CLARKSBURG CHASE PRE-PRELIMINARY PLAN NO. 720230020

Description

MCPB

Item No. 15
5-4-2023

Figure 4 – Pre-Preliminary Plan

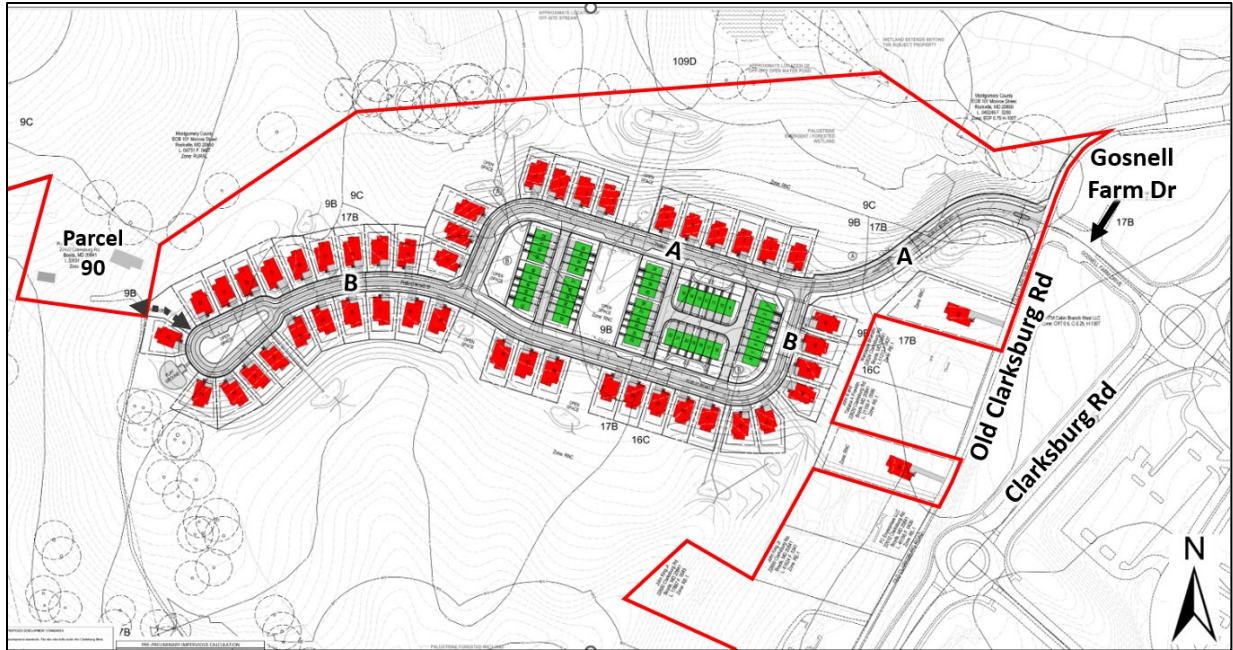
Staff supports the general layout, single-access point, non-standard cul-de-sac and general location of the units and mix of detached and attached dwelling units. However, as discussed in finding 3 below, Staff is requesting an additional pedestrian and bicycle connection to provide additional access to and from the development.

While Staff does support the layout, it's important to note that the proposed road design will need further review. Per Section 4.3.E.2.e of the Subdivision Regulations, governing the creation of non-through roads, the Applicant will need to request a Subdivision waiver to

The Applicant proposed multiple “styles” of single-family detached units and townhouse units. The Applicant is proposing 100¹ units on a single vehicular access point. Per MCDPS, Fire Access and Water Supply Section, only 99 units are permitted from a single access point.

As conditioned, the Applicant will be required to reduce the number of dwelling units to no more than 99 units or provide a second point of vehicular access to the units (Attachment C).

1. Site Access and Public Road ‘A’ – At the time of Preliminary Plan, the Applicant must submit justification for a waiver to create of a non-through road (single access point) longer than 500 feet, that serves more than 75 dwelling units, pursuant to Section 4.3.E.2.e of the Subdivision Regulations.
2. The Applicant must provide a second point of fire department vehicular access to the interior portion of the development or reduce the number of dwelling units (existing and proposed) being accessed from the single access point on Old Clarksburg to 99 units or less.

Figure 6 – Proposed Pathway connections

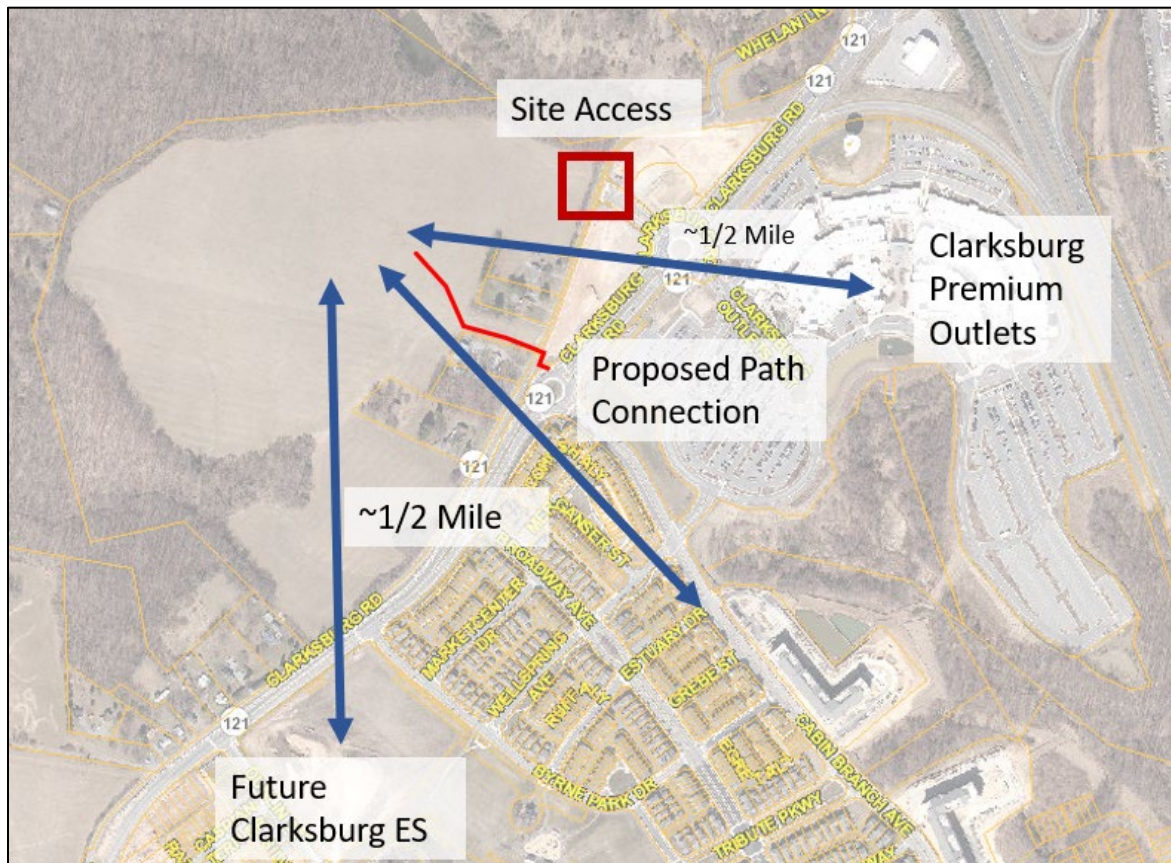
Staff recommends the inclusion of at least one additional bike and pedestrian connection to serve the community. The Applicant proposes to provide a single access point to the proposed development originating at the existing intersection of Old Clarksburg Road and Gosnell Farm Drive. While this may be adequate for fire access and vehicular circulation (pending final

approval from Montgomery County Fire and Rescue Services), a single access point limits bike and pedestrian access to and from the adjacent Cabin Branch Community. For example, the center of the proposed development area will be approximately ½ mile to the Clarksburg Premium Outlets, a major region-wide retail destination, the future Clarksburg Cluster Elementary School #9, as well as the center of the Cabin Branch residential community.

To facilitate bike and pedestrian access to these destinations, Staff recommends the Applicant construct a paved shared use path to connect from the center of the proposed development area to Clarksburg Road at the traffic circle with Cabin Branch Avenue. This will require crossing Old Clarksburg Road and providing a ramp to connect to the lower grade of Clarksburg Road.

6. Path Connection – The Applicant must design and construct a paved shared use path approximately from the center of the development area, between proposed lot 43 and 44, to connect to Clarksburg Road. The path must include a crossing of Old Clarksburg Road and if necessary, a ramp connecting to the existing bicycle and pedestrian network on Clarksburg Road, near the intersection with Cabin Branch Avenue.

Figure 7 – Proposed Trail Connection

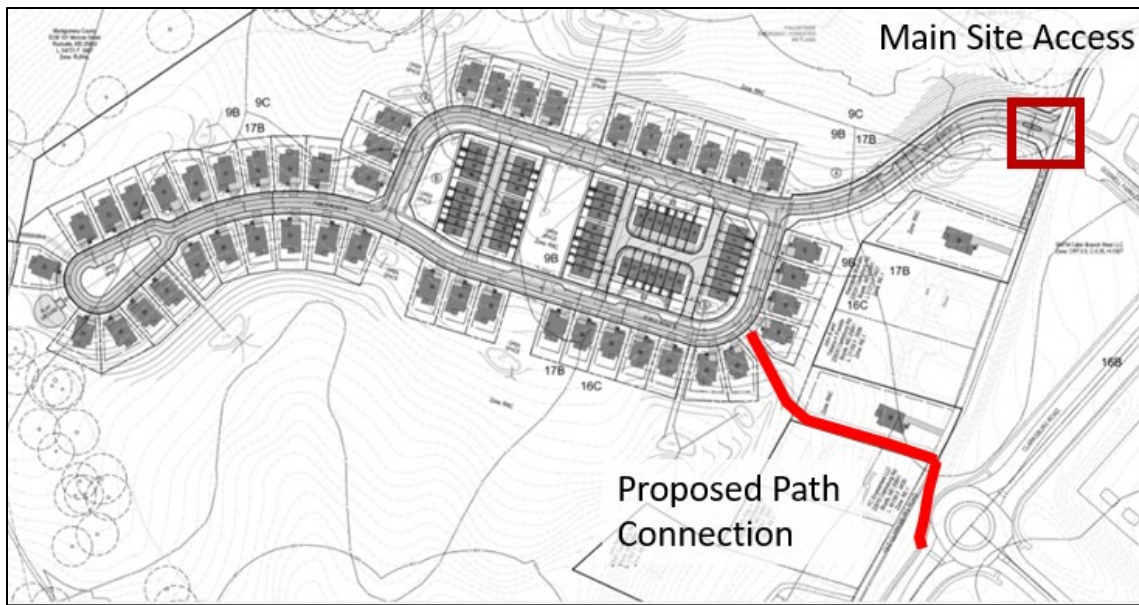
The addition of the path would provide a more direct route for cyclists and pedestrians to points to the south, particularly the proposed elementary school. The connection would reduce the journey by approximately 1,000 feet, reducing walking time by roughly 4 minutes in comparison to the Applicant’s no-build option. This would maintain a total walk time of roughly 10 minutes from the trailhead to the school, versus a roughly 14-minute walk with the no-build option; the reduction in time would likely result in a significant increase in biking and walking trips to and from the elementary school. The path would also connect to the existing sidepath along the south side of Clarksburg Road. In contrast, the Applicant’s no-build approach would likely reduce if not eliminate non-vehicular trips to the school and points south.

The addition of a ten-foot-wide asphalt path connection would result in the addition of roughly 7,000 to 10,000 square feet of impervious surface. This coverage would need to be compensated for elsewhere within the application. Potentially, this can be accomplished with limited impact to the development scale by reducing other impervious surfaces such as typical driveway widths.
